Entergy Operations, Inc.
1340 Echelon Parkway
Jackson, MS 39213

G3NO-2008-00005

DOCKET: No. 52-024

SUBJECT: Responses to NRC Requests for Additional Information, Letter No. 6 (GG3 COLA)

Figure RAI 10.4.5-3-1 Site Drainage Hold-up Area

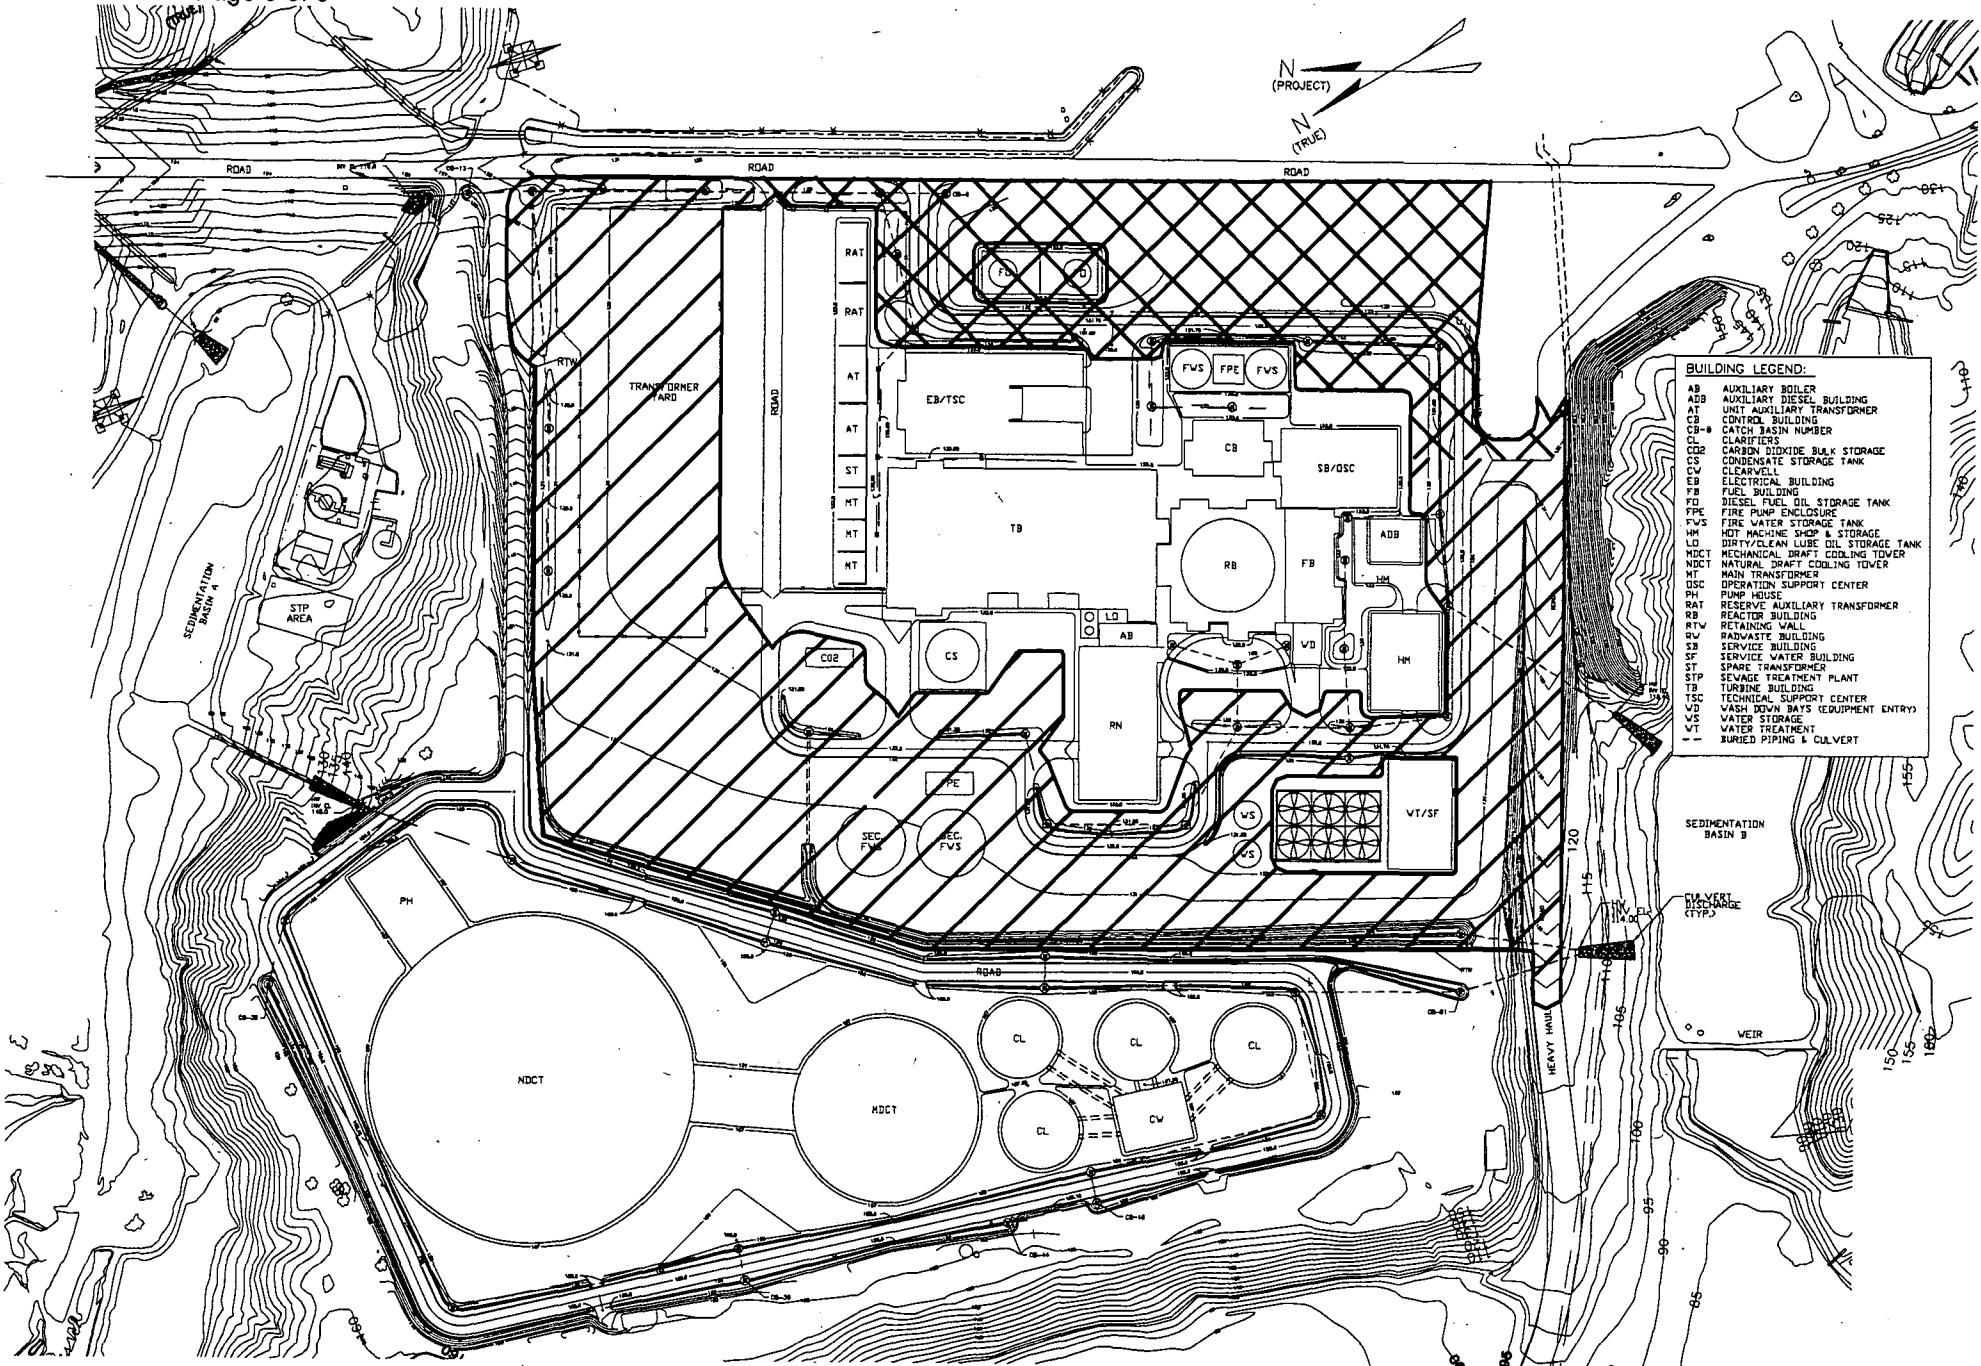
The staff reviewed the information provided by the applicant in FSAR Section 10.4.5.8 and could not find further details on the location of the MDCT. Also, the staff could not find any design features to prevent or control the flooding effects in case of a cooling tower failure (i.e., missile generation) on the nearby safety-related areas and/or the safety-related SSCs as they relate to the requirements of GDC 4 criteria. Also, no information is provided in the COLA with respect to Section 10.4.5.6, "Flood Protection," of the ESBWR DCD, Revision 4. In accordance with SRP Section 10.4.5, "Circulating Water System," Item II.1, design provisions need to be provided to accommodate the effects of discharging water that may result from a failure of a component or piping in the CWS. Therefore, the staff requests that the applicant provide additional information regarding its cooling tower failure analysis or the provisions that are incorporated in the GGNS CWS design to prevent unacceptable flooding of areas containing safety-related equipment or to mitigate the consequences of flooding.

Considering the site grading design, and including the area indicated by the cross-hatch on Figure RAI 10.4.5-3-1, which includes all areas around the power block periphery between elevations 133 ft msl and 129 ft msl, the volume of water (not including the volume of the passive drainage system, drainage ditch, culverts, catch basins and swales) that could be accommodated with no drainage is approximately 37,090 m³ (9,700,000 gals). Considering only the areas to the north, south, and west of the power block, a volume of approximately 30,840 m³ (8,000,000 gallons) could be accommodated in the remaining area between the site grade of elevations 133 ft msl and 129 ft msl. These volumes bound the entire volume of the CIRC cooling towers.
